Our Reference: **PT18071**

**Proposed Residential Development - 38-58 Somerset Ave, Narellan**  
**Reponses to Council Email Dated 5 November 2019**

As requested, we have reviewed the issues raised in the email dated 5 November 2019 from Ms Clare Aslanis of Camden Council on traffic / modelling matters. A copy of this email is provided in **Appendix A** of this response report.

**Figure 1 - Adopted Intersection Configuration of Camden Valley Way / Somerset Avenue**

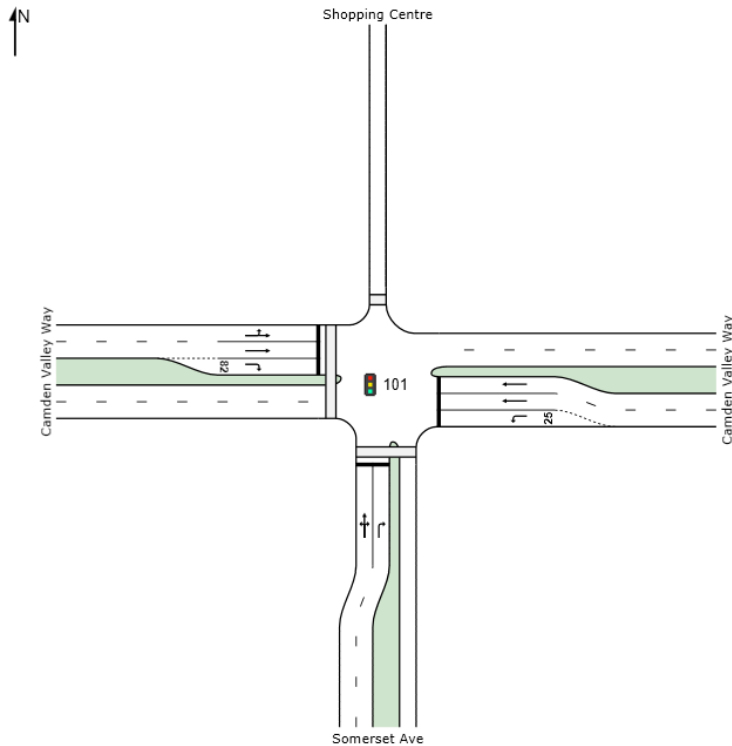
1. The SIDRA intersection analysis may be slightly skewed due to incorrect road layout on the westbound lanes of Camden Valley Way. The report incorporates 3 lanes whilst there should be 4 lanes.
3. There have several complaints received by Council regarding queuing on Somerset Avenue in its existing state, however the data appears to show that the intersection operates at a level of service C -this may be because they input the western lane of Somerset as a full length lane rather than a short lane as parking is permitted 60m away from that intersection. It would be ideal to have the SIDRA analysis revised to show the correct form of the roadway as discussed in point 1 and also identify the western lane of Somerset avenue as a short lane with respective length up to where on-street parking is permitted.

The arrangement for the intersection of Camden Valley Way / Somerset Avenue adopted in all modelling to date is presented below in **Figure 1**.

The layout adopted for the Camden Valley Way / Somerset Intersection is acknowledged to have less capacity that is available for 'eastbound' traffic in Camden Valley Way. That is, two (2) lanes were adopted for eastbound traffic whereas three (3) lanes are available.
